OLD vs CURRENT HAMMER DESIGNS

S&W Supply, LLC

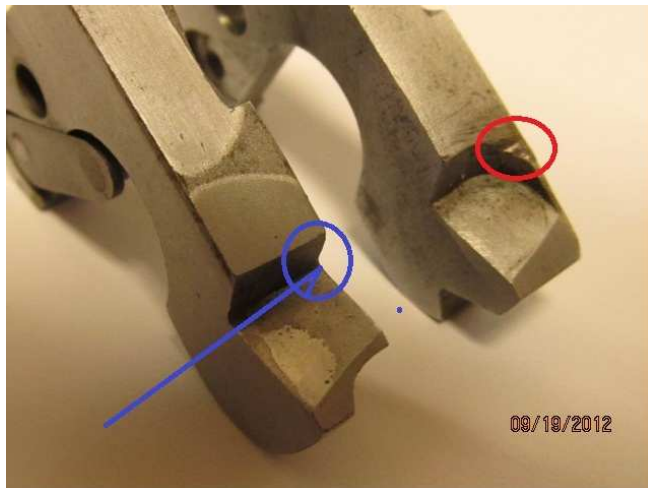
Old style firing pins had/have a small machined slot on their right-rear's which permitted the old style hammer to hit the back of the firing pins and avoid striking the right side of the firing pin.

Using a current design RH firing pin with an old style hammer can cause some irreparable damage to the receiver's firing pin hole.

Reason for the changes: Old technology for hardening hammers saw the entire hammer being heat-treated for extra hardness. Present day technology electronically hardens only the striking surface, the notch area where the sear engages the hammer, and the surface where the cocking foot, cocks the hammer. As a result, Perazzi no longer needed to maintain the "web" in their new, current RH hammers, and also ceased modifying the related firing pins.

The photo below does show hammers removed from a release trigger gun (notches in the tops of the hammers for the release hooks), but this does not alter the above discussion.

Any competent gunsmith or handyman can remove the web. The concern is to leave just a very, very small web at the ~90° angle so as to prevent cracking at some future point. You can always install a current hammer as well.
